SEWAGE DISPOSAL TESTING

HOWARD COUNTY HEALTH DEPARTMENT
ENVIRONMENTAL HEALTH SERVICES

PROPERTY OWNER JOHN F. & Phyllis K. BRINKER
ADDRESS 12275 CARROLL MILL RD. PHONE 988-9513
ELLICOTT CITY, MD.
PROPERTY LOCATION: WOODMARK LOT NO. Lot 4 Resubdivision of LOT 6
ROAD AND DESCRIPTION TRADEPEDIA RD & CARROLL MILL RD.
RESUBDIVISION OF LOT 4
SIZE OF LOT APPROX 5 1/2 AC TYPE BLDG. Homes (4)
(NUMBER OF BEDROOMS)

Re-sub of Lot 4

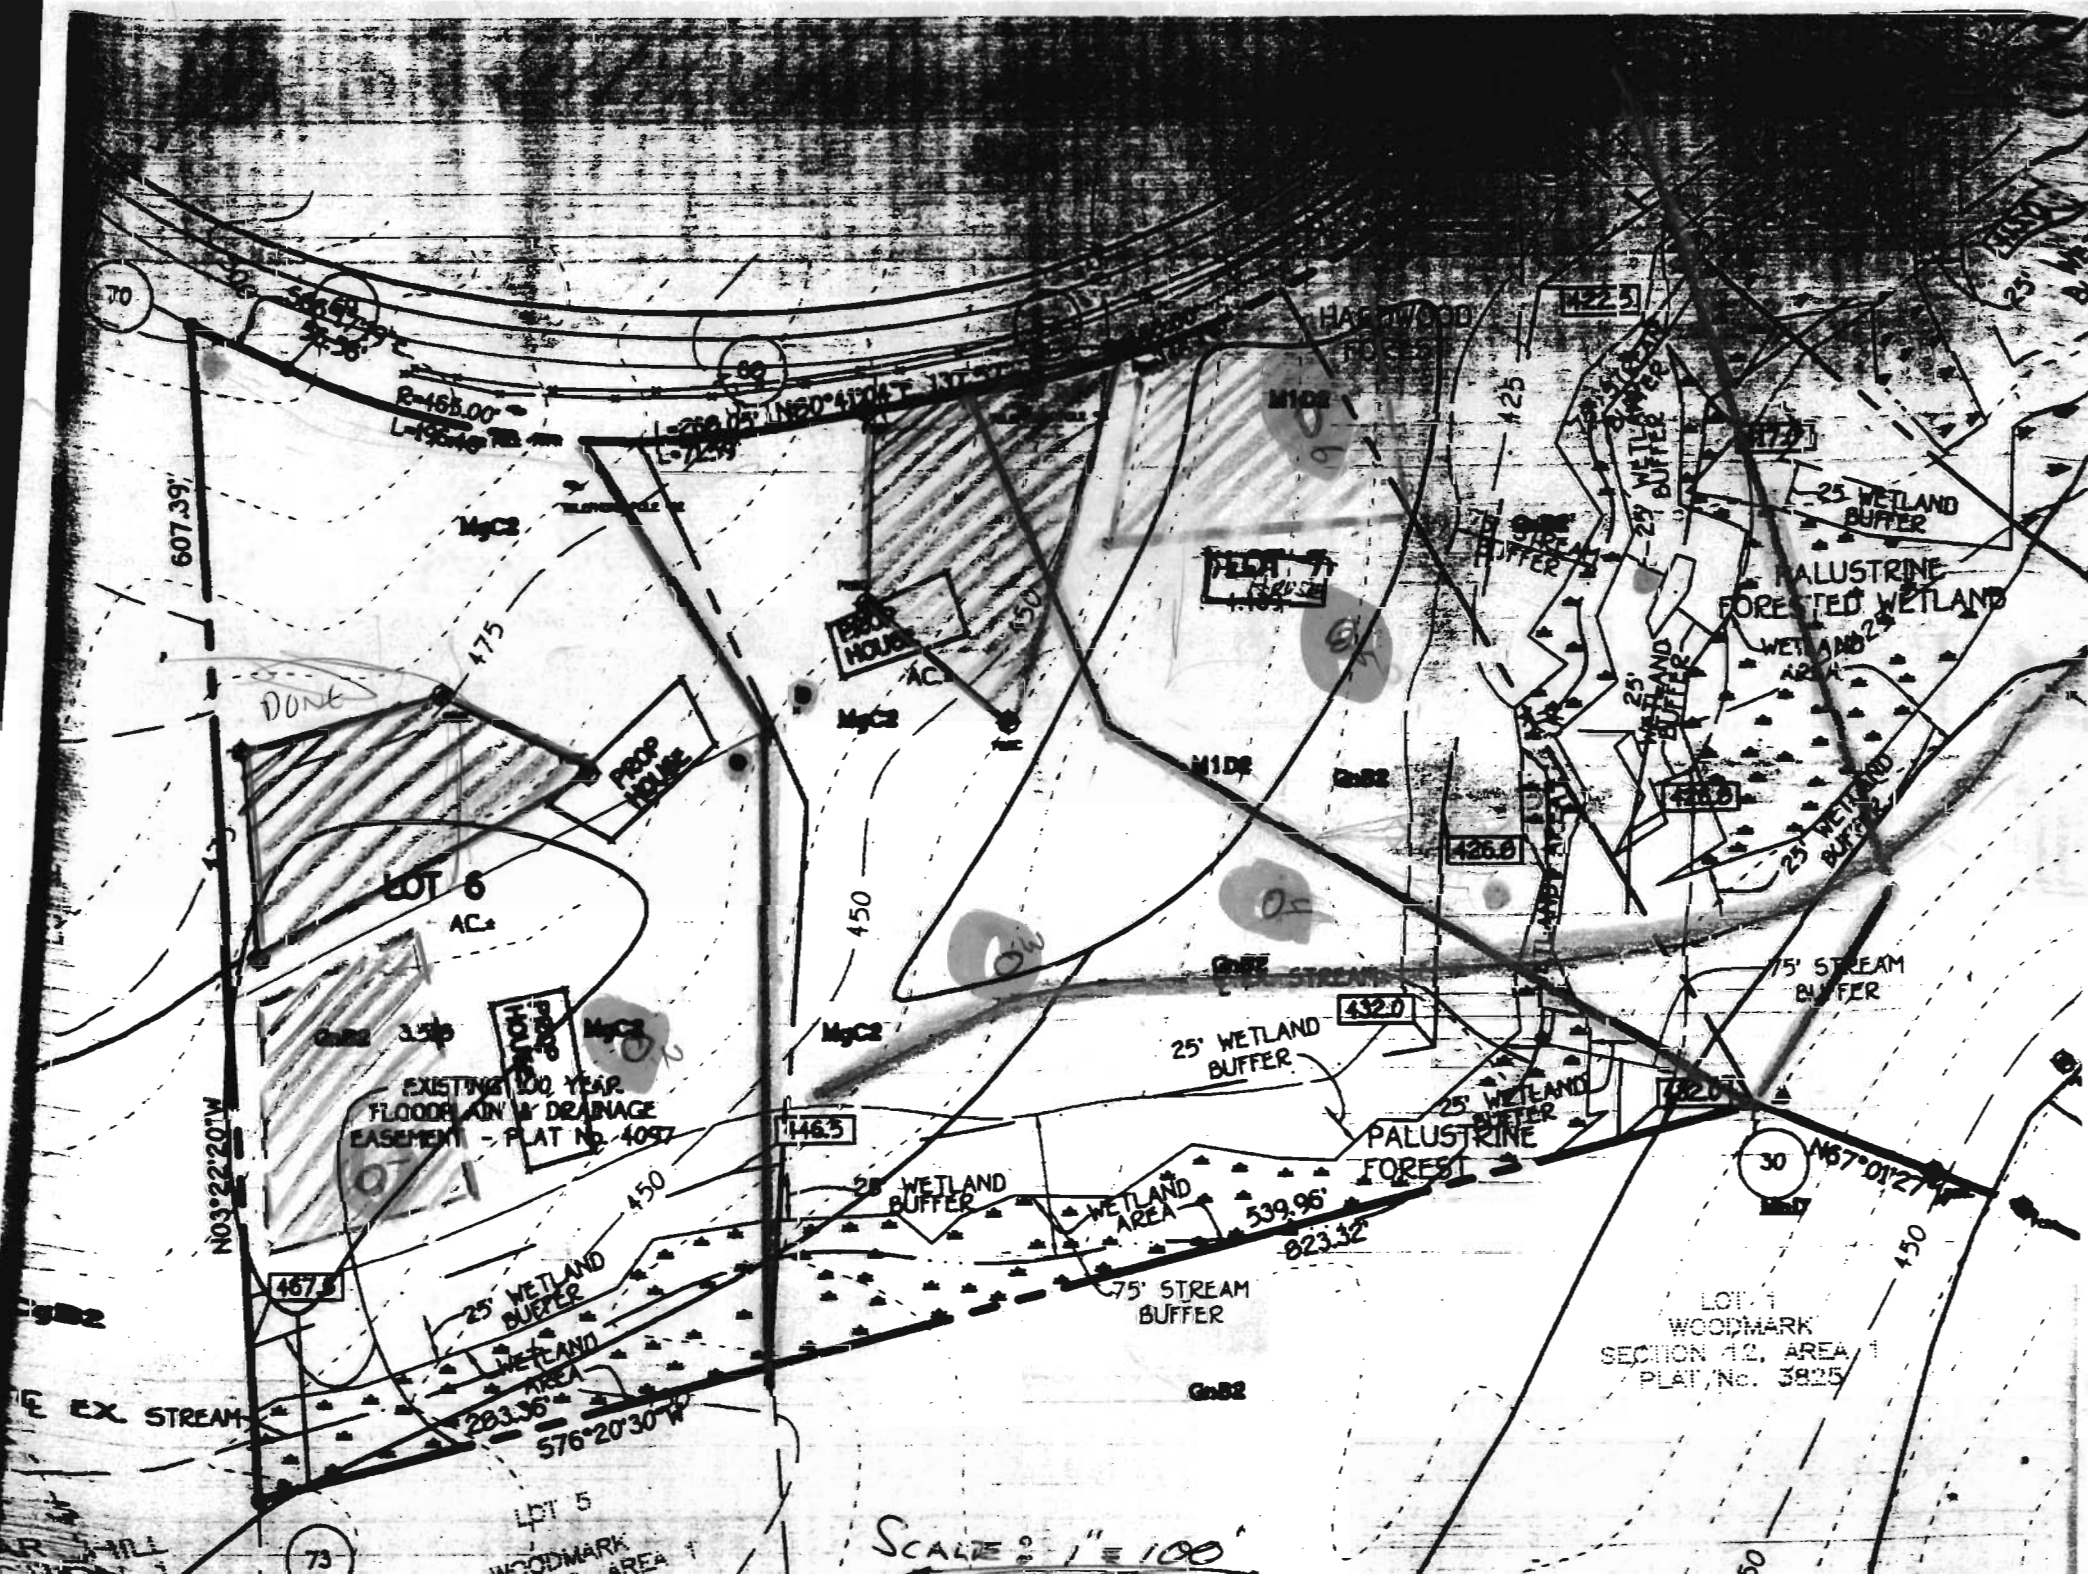
10/14/82 PERC OK EXISTING HOUSE SYSTEM

REMARKS OK BUT COULD NOT RUN WATER TEST

10/21/82 WATER TEST RUN & IS OK RH

Re-sub. of Cat 4

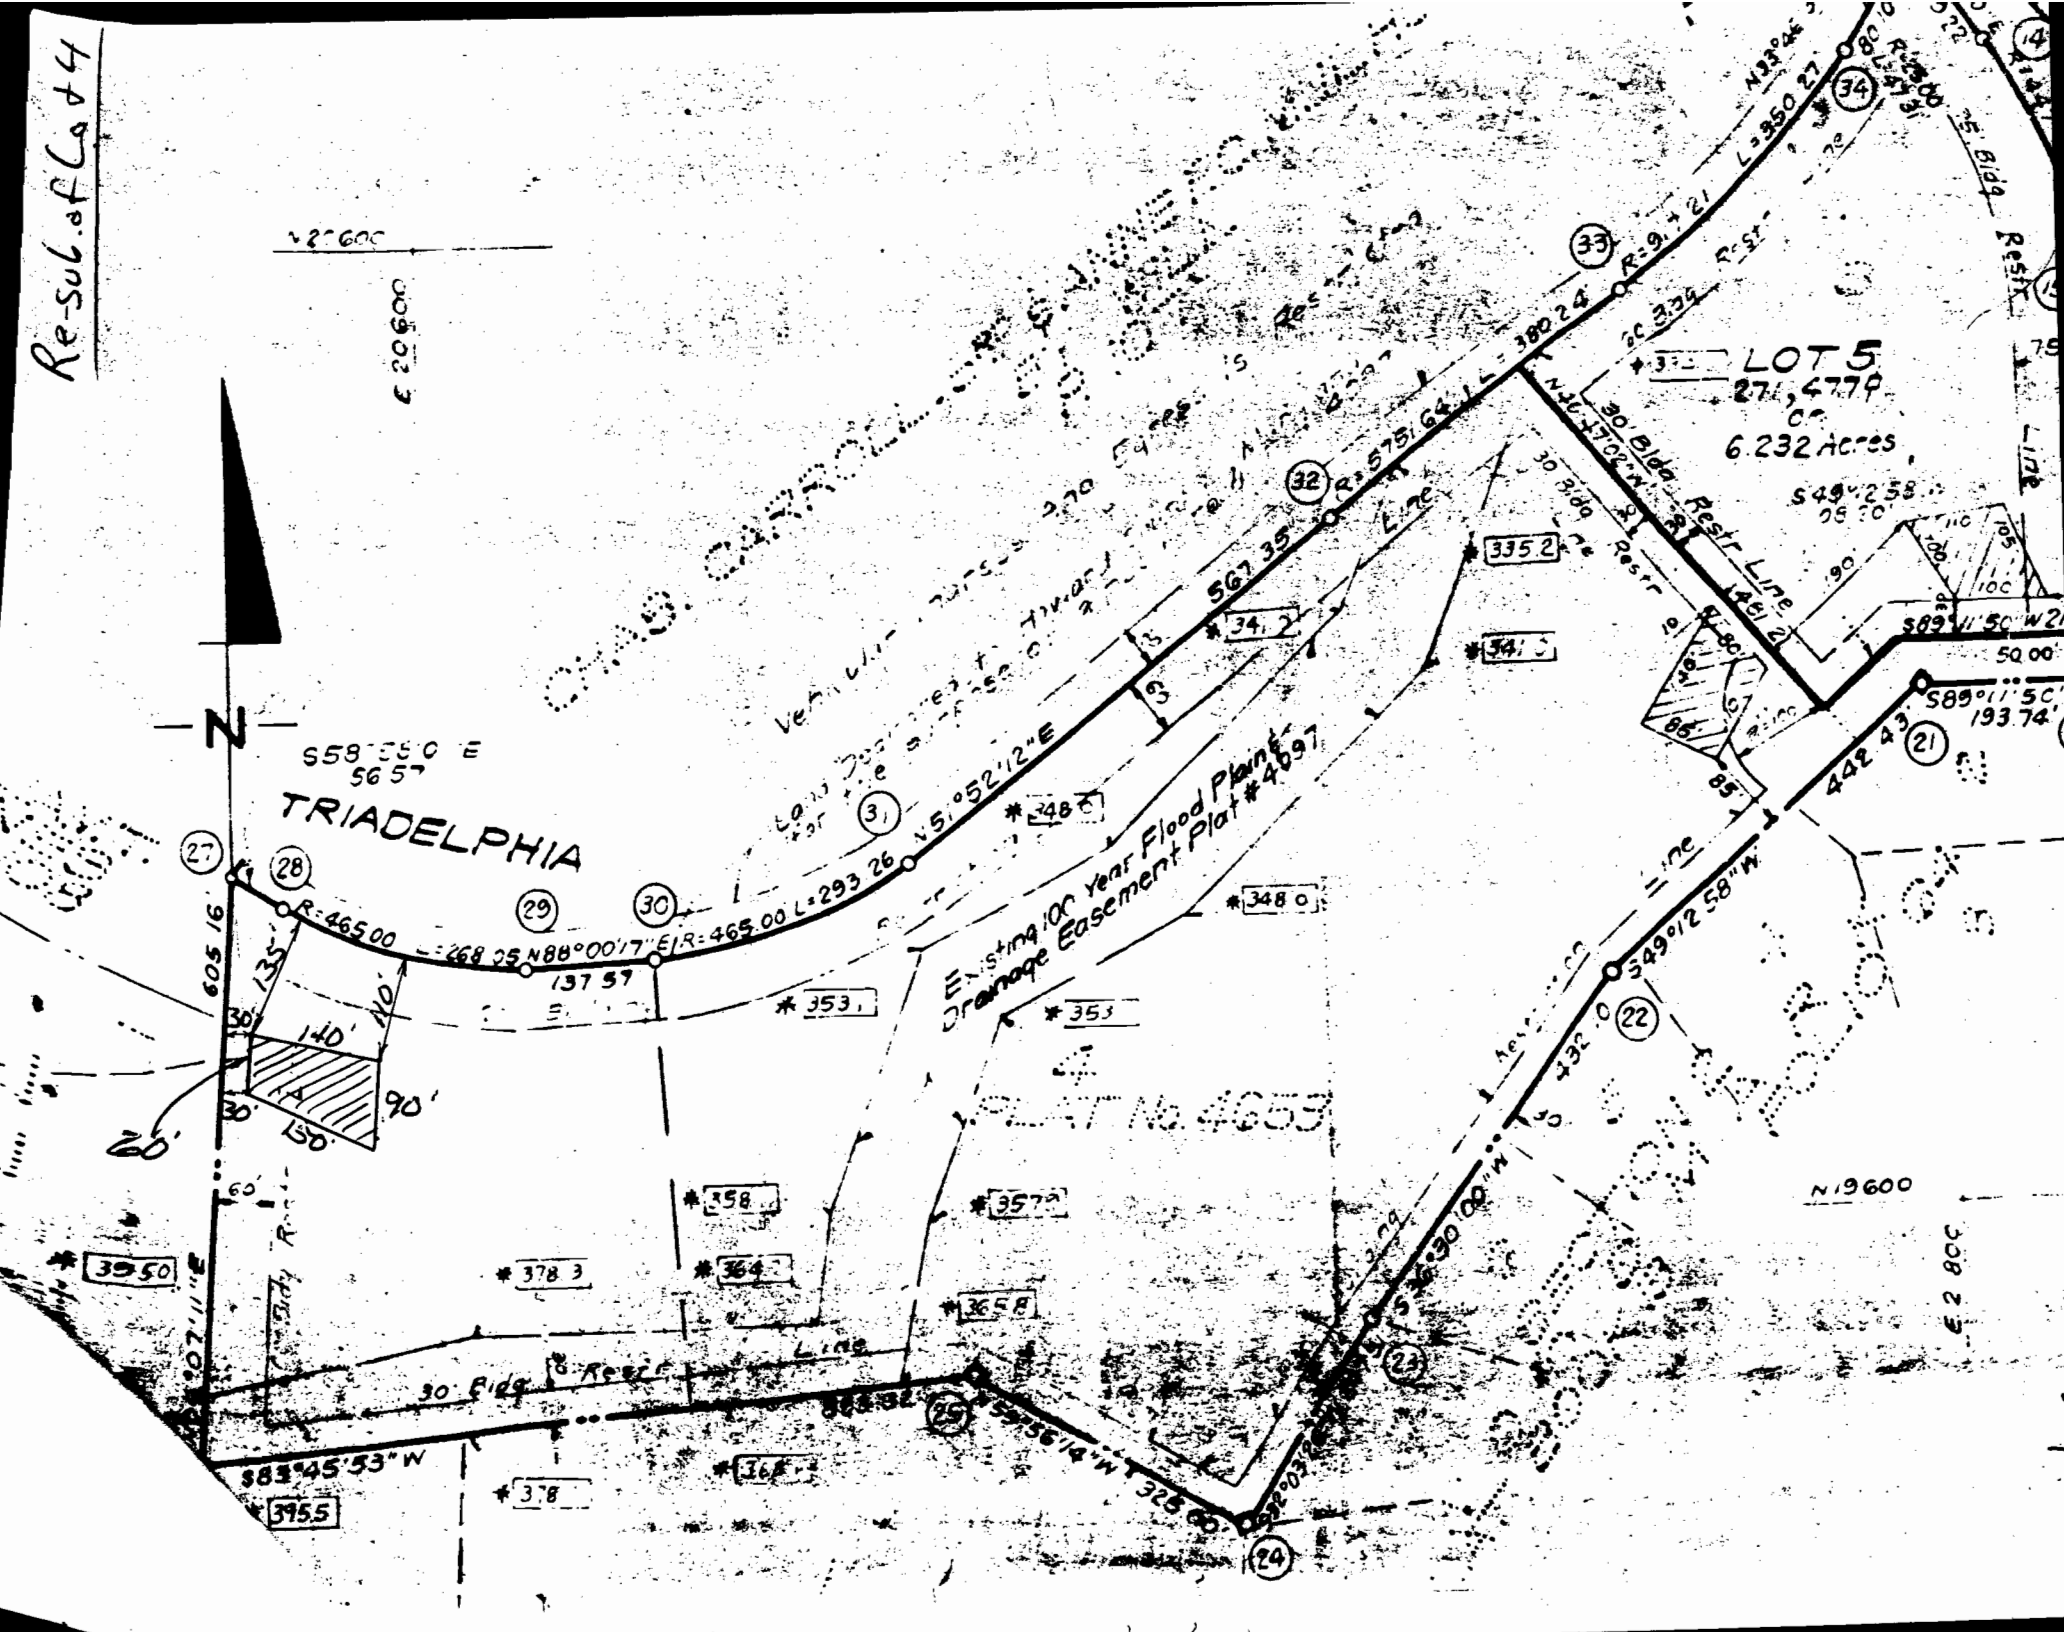
LOT 10 EXISTING HOUSE 12275 CANNON AVE #A27619
SHOW EXISTING SYSTEM (MAY BE ACROSS PROPOSED LOT LINE)
PROPOSE MODIFIED SEPTIC AREA AS TIGHT AS POSSIBLE
TO EXISTING AREA. ON GO FOR RE-PLAN TO
PROVE EXISTING PROPOSAL.

LOT 12 EXISTING HOUSE 12285 CANNON AVE A32288
^{NO CHANGE IN WELL & SEPTIC.}
EXISTING WELL IS IN OFF LOT EASEMENT,
PROPOSAL MAINTAINS THIS ARRANGEMENT
WELL LOCATION IS IN CONFLICT WITH LOT 11
SEPTIC AREA WHICH IS TO BE MODIFIED.

LOT 11 A27618 - PROPOSED BY ISSUED, BUT NOT BUILT.
SEPTIC AREA IN CONFLICT W/ EXISTING WELL
& WELL LINE EASEMENT. MODIFY IS SHOWN.
SEE NOTE ABOUT ^{EXISTING} SEPTIC SYSTEM LOT 10.

LOT 8 A 39496 (OLD LOT C)
SLIDE SEPTIC AREA UPHILL 1 CONTAIN INTERVAL
* NEED CHECK ^{INSTALLER} SEPTIC LOT 1 SECT 12
* L8 BLOCK B SECT 11

LOT 9 A 33323 (OLD LOT 4)
REFINE STEEP SLOPE TO BE 25' FROM SEPTIC
NEED TO KNOW ~~LOT~~ 546 WOODMARK SECT 2
SEPTIC AREAS VERY WELL
BEFORE DETERMINATION OF WELL SITE,
MAINTAIN TESTED SEPTIC CONFIGURATION OR
TEST IN CENTER OF PROPOSED PATTERAN
ADD FAULTS TEST HOLE

REFINE AREA AS SHOWN TO FACILITATE
TRENCH INSTALLATION

COT 6 A322~~27~~ — OK AS SHOWN —
